**ADDENDUM #1
NCDOT TIP: EB-5014
LOVILLS CREEK AND ARARAT RIVER GREENWAY – MOUNT AIRY, NC**

ISSUED DECEMBER 11, 2014

LOVILLS CREEK AND
ARARAT RIVER GREENWAY
WORTH STREET TO THARINGTON PARK

LOVILLS CREEK BRIDGE END BENT 1

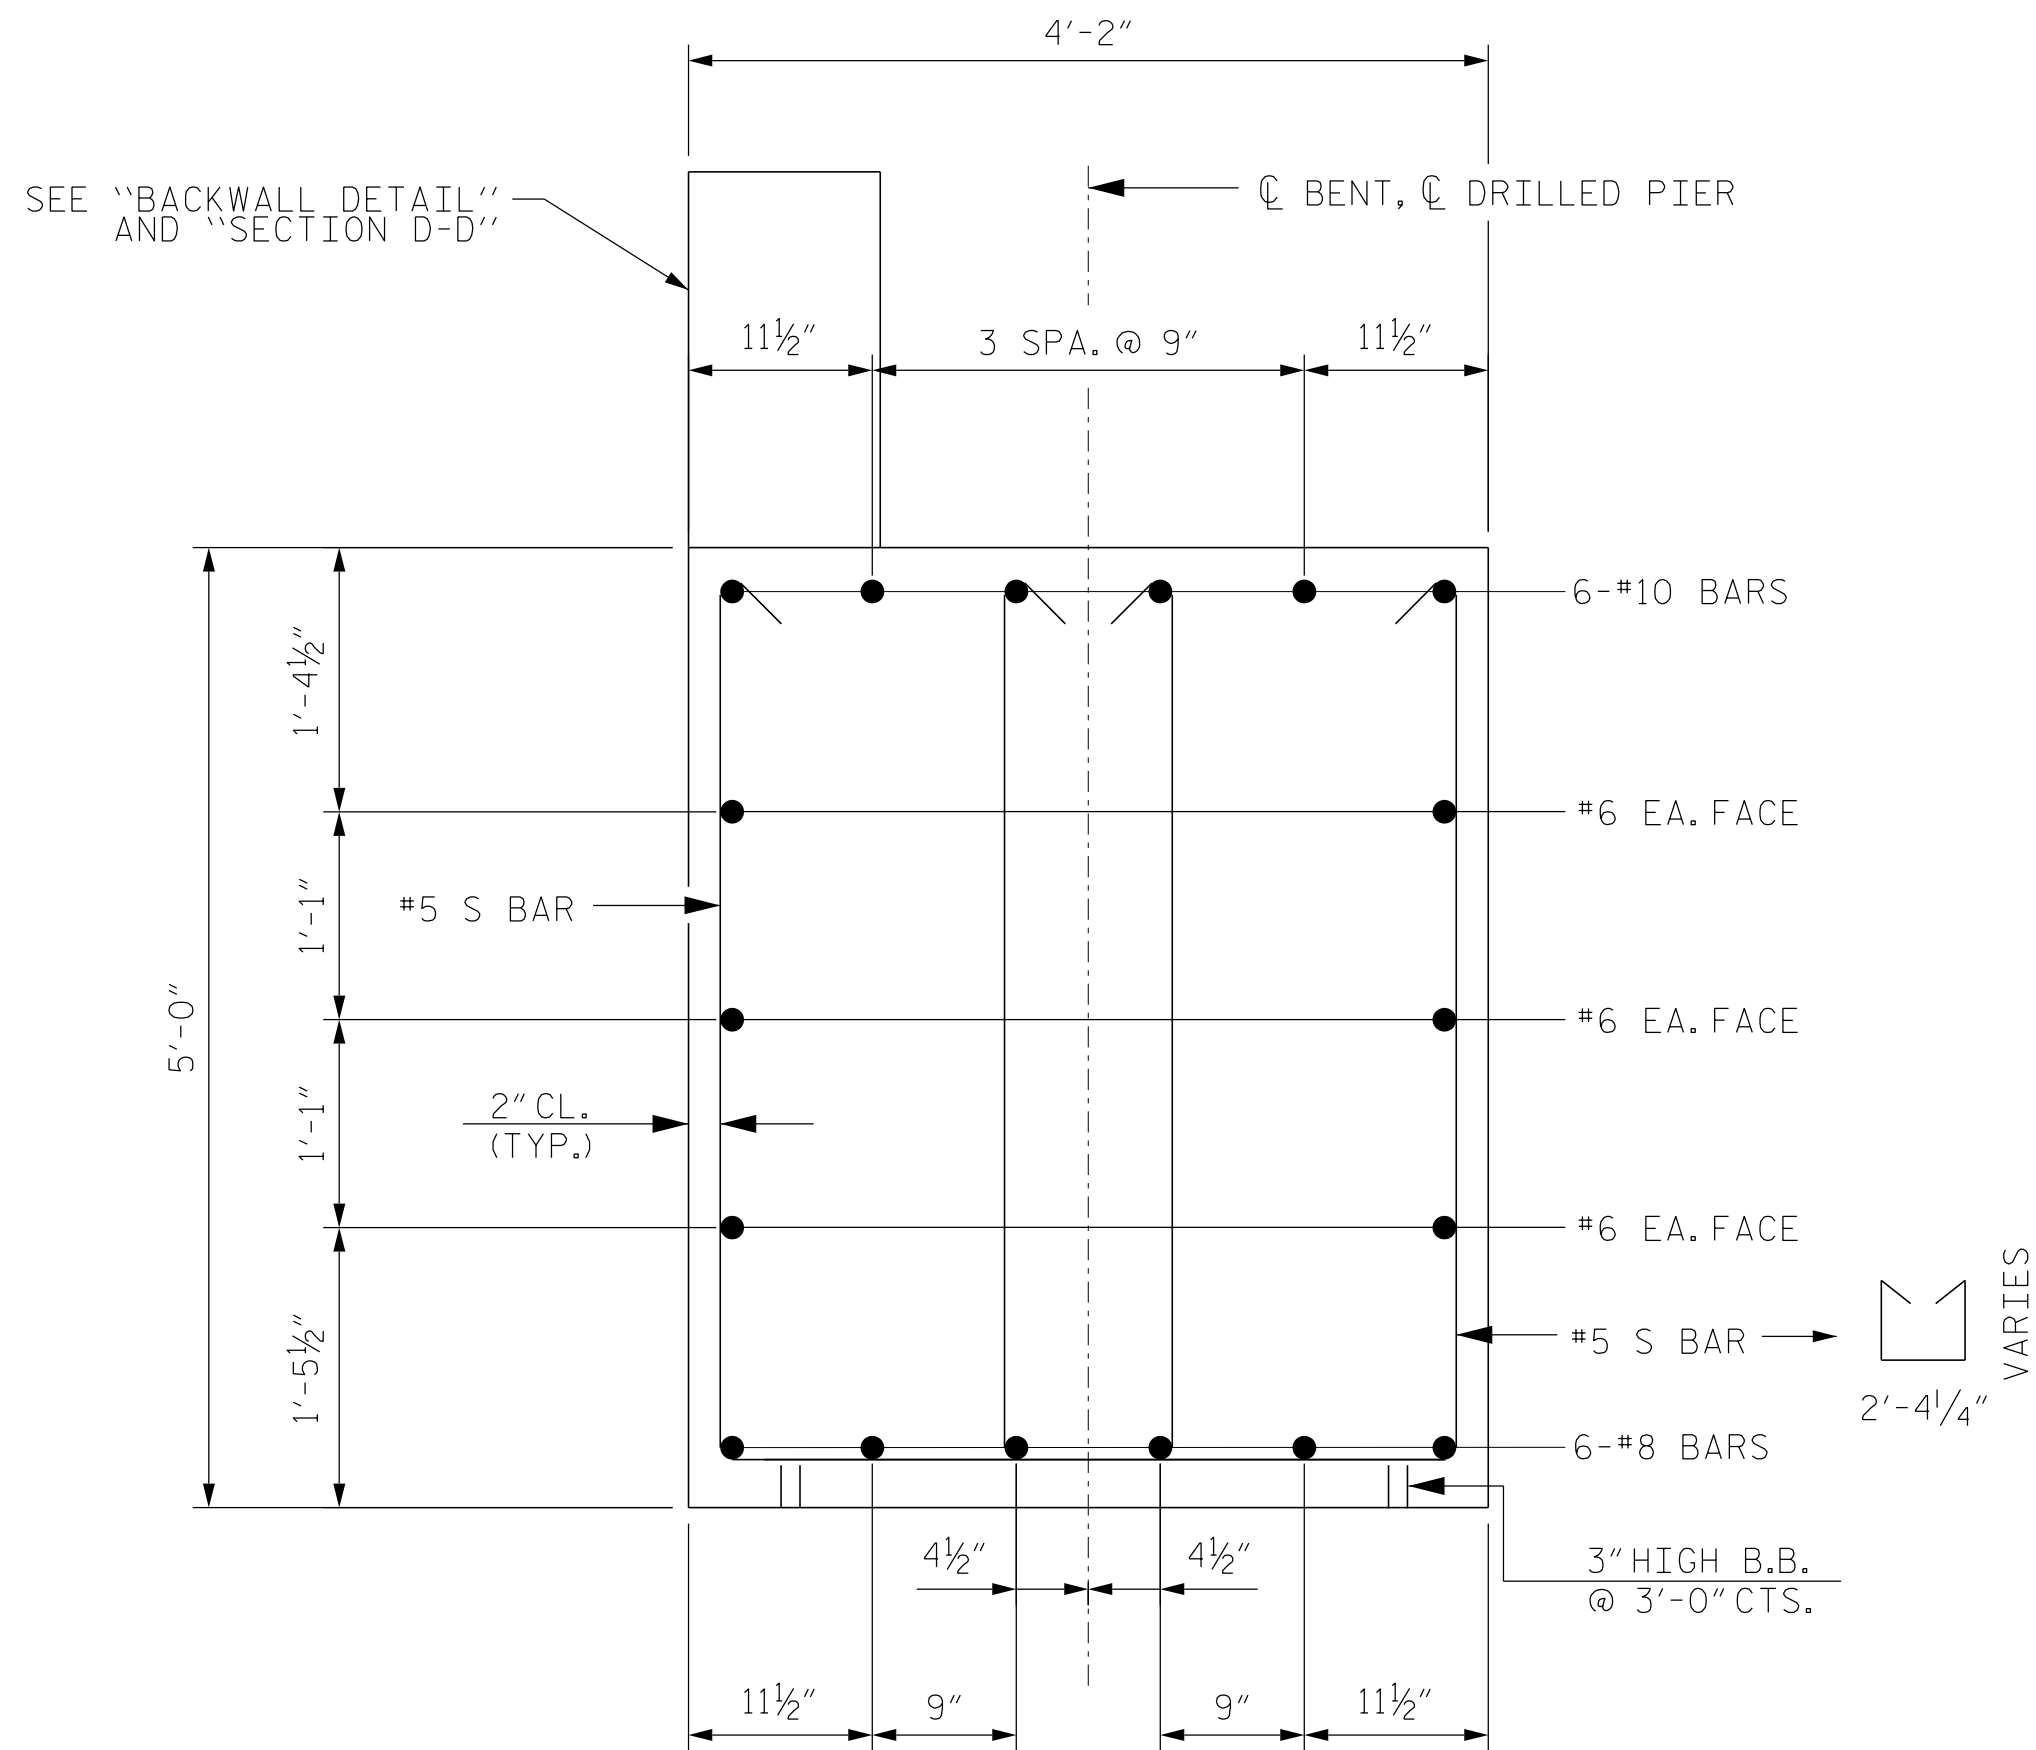
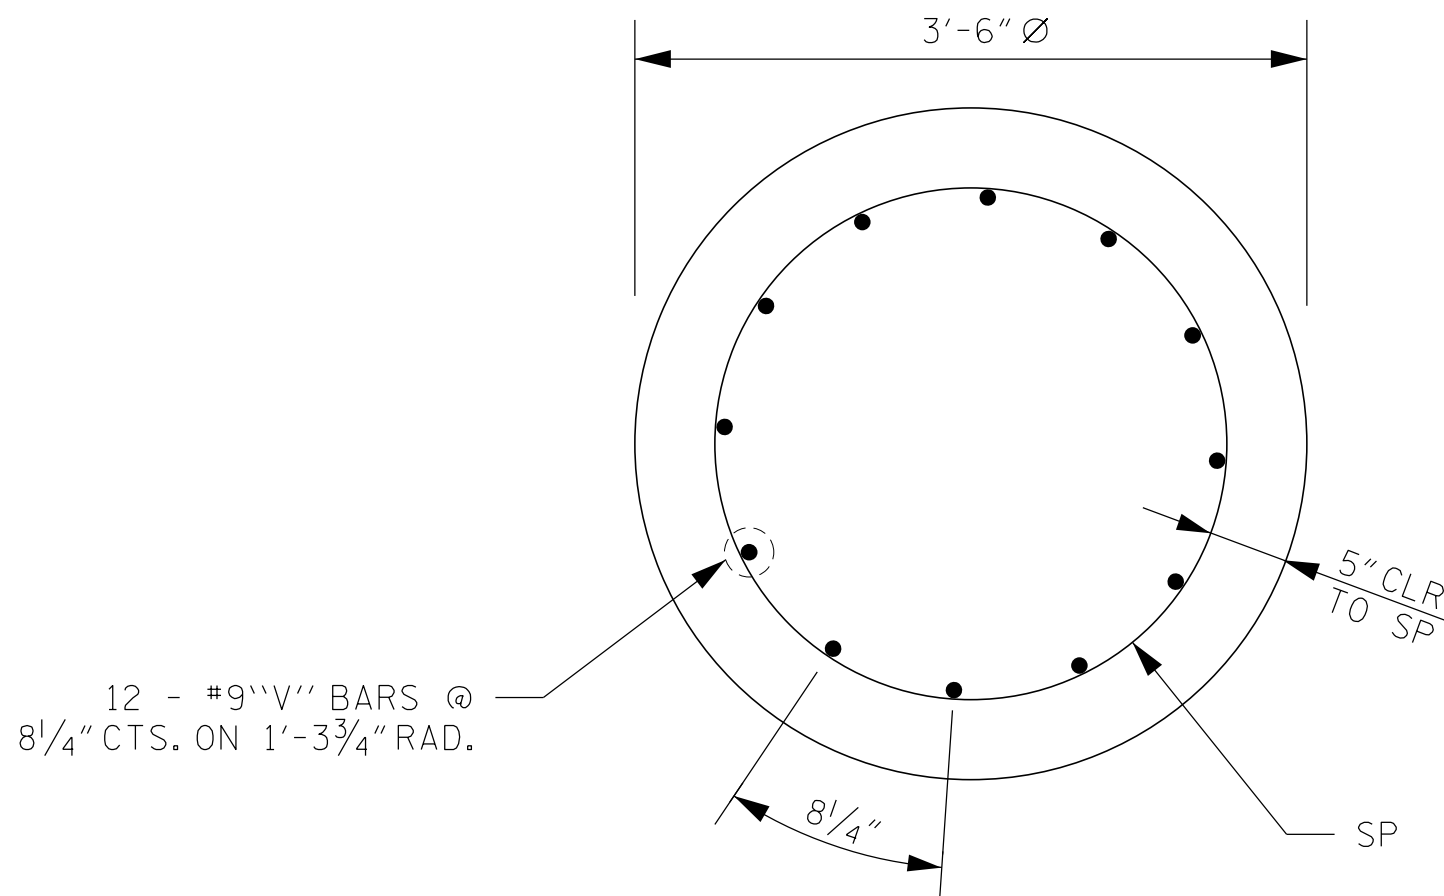
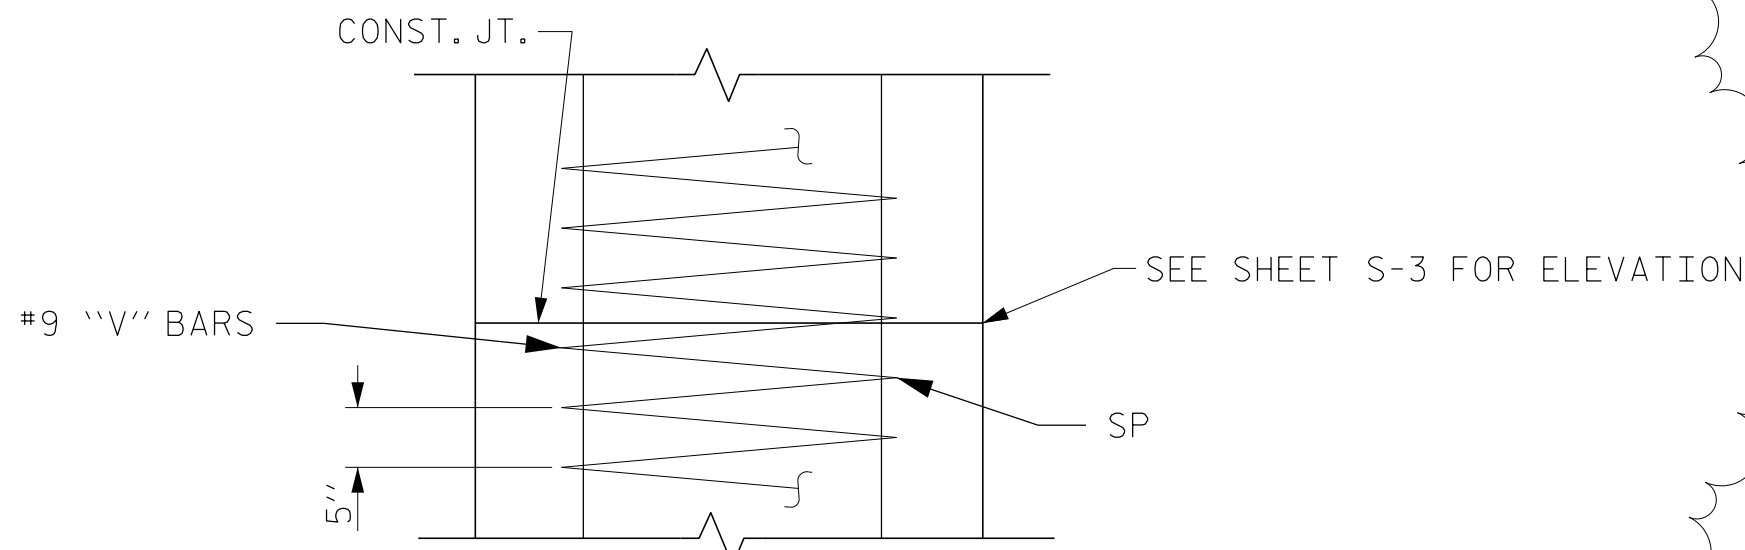
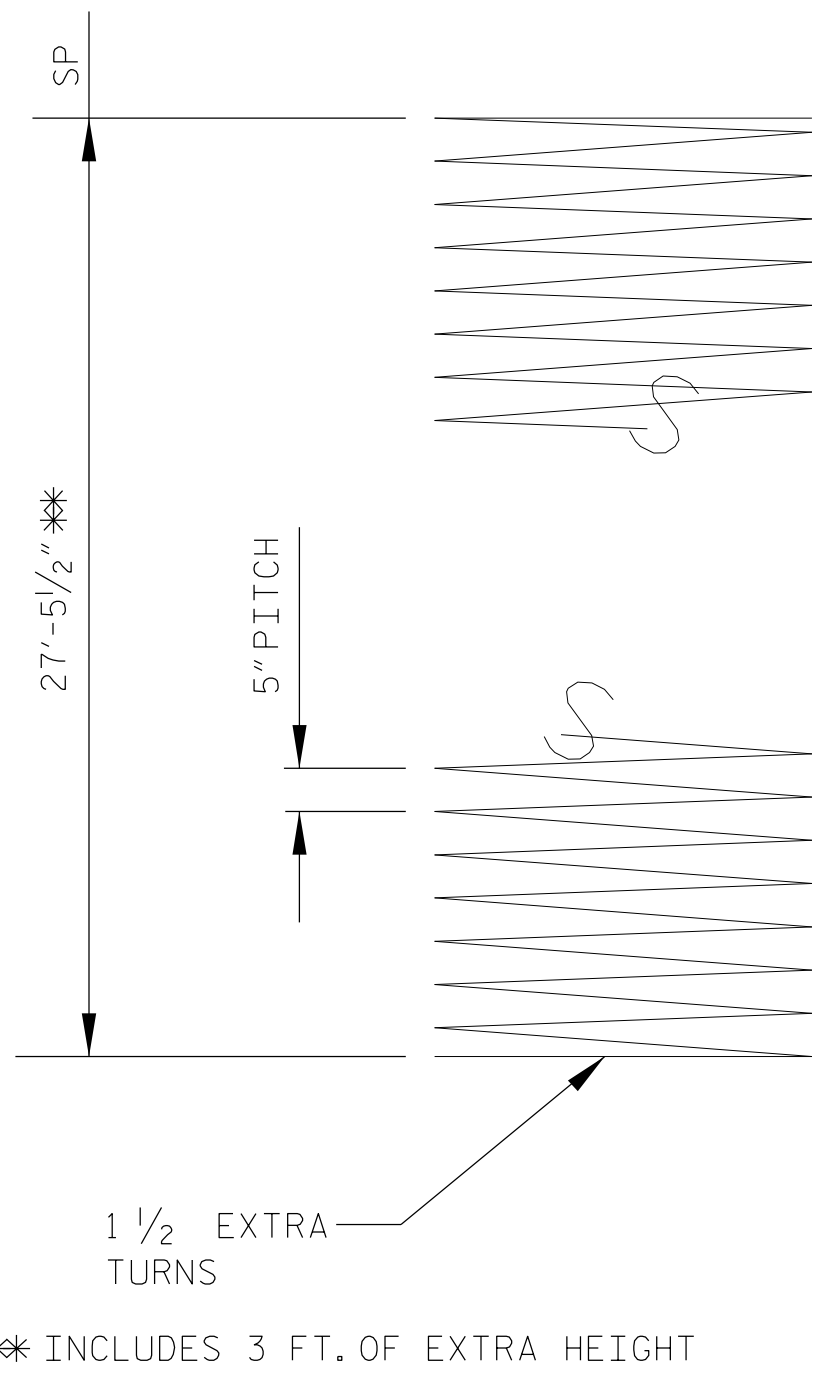
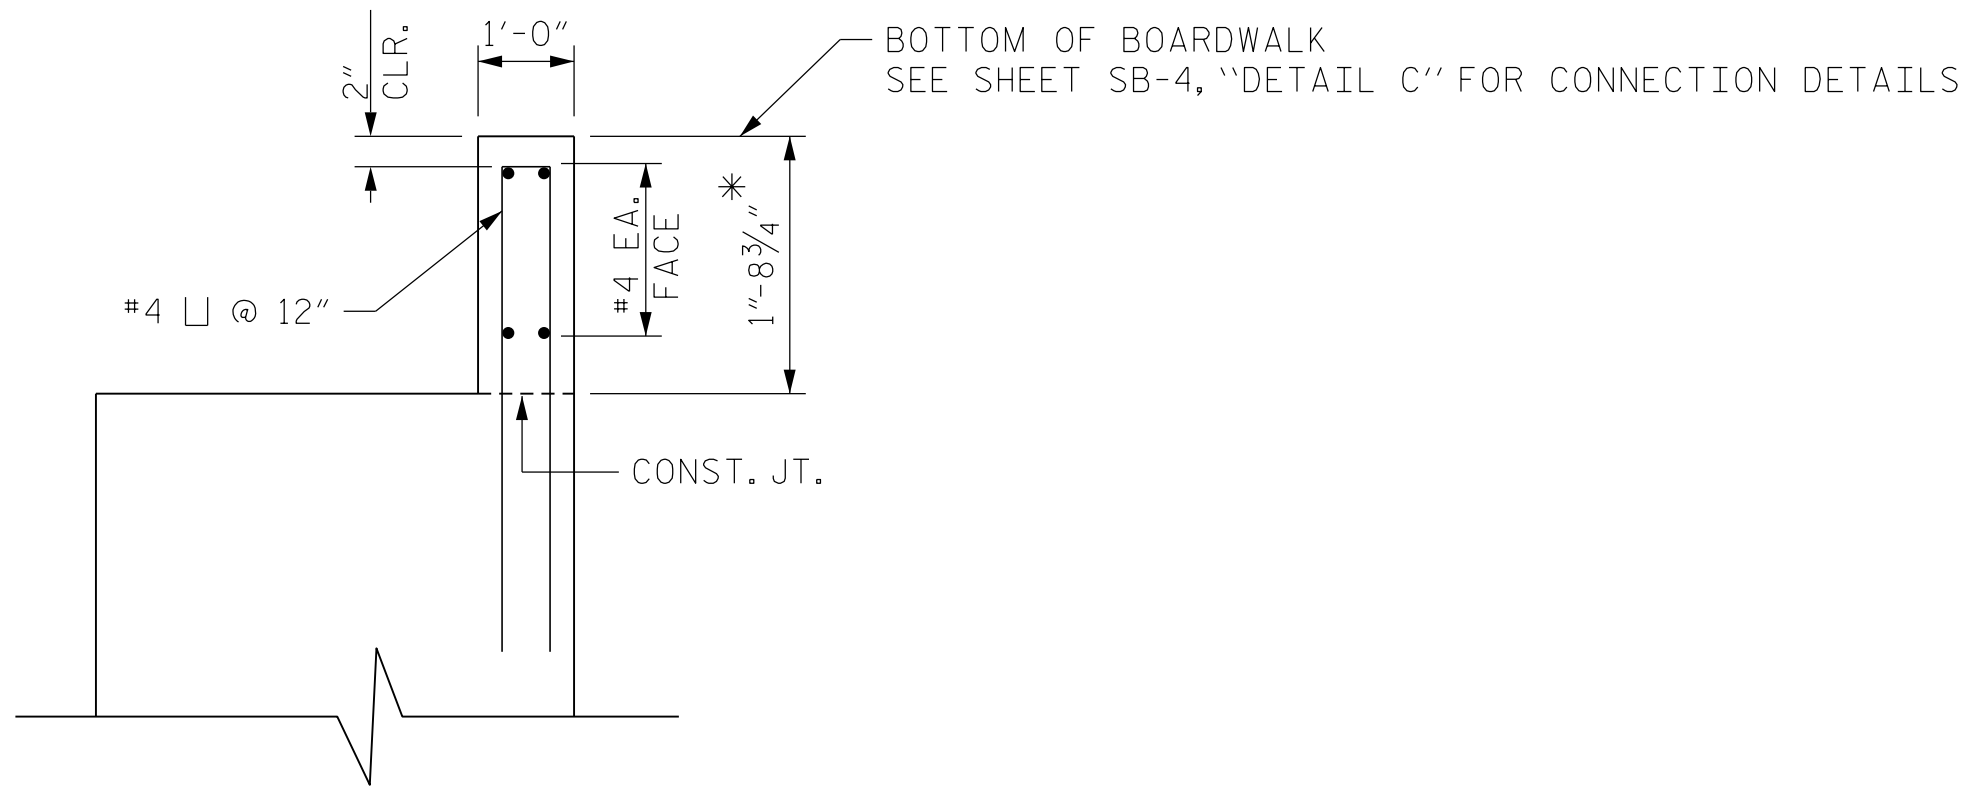
- Typical section limits on sheet 2 have been clarified.
- Plan sheets S1, S3, S4, S5, S6, and SB-1 have been modified to reflect final NCDOT review comments.

ADDED OPTIONAL CONSTRUCTION JOINT

1 THE LOCATION OF THE CONSTRUCTION JOINT IN THE DRILLED PIER IS BASED ON AN APPROXIMATE GROUND LINE ELEVATION. IF THE CONSTRUCTION JOINT IS ABOVE THE ACTUAL GROUND ELEVATION, THE CONTRACTOR SHALL PLACE THE CONSTRUCTION JOINT 1 FOOT BELOW THE GROUND LINE.
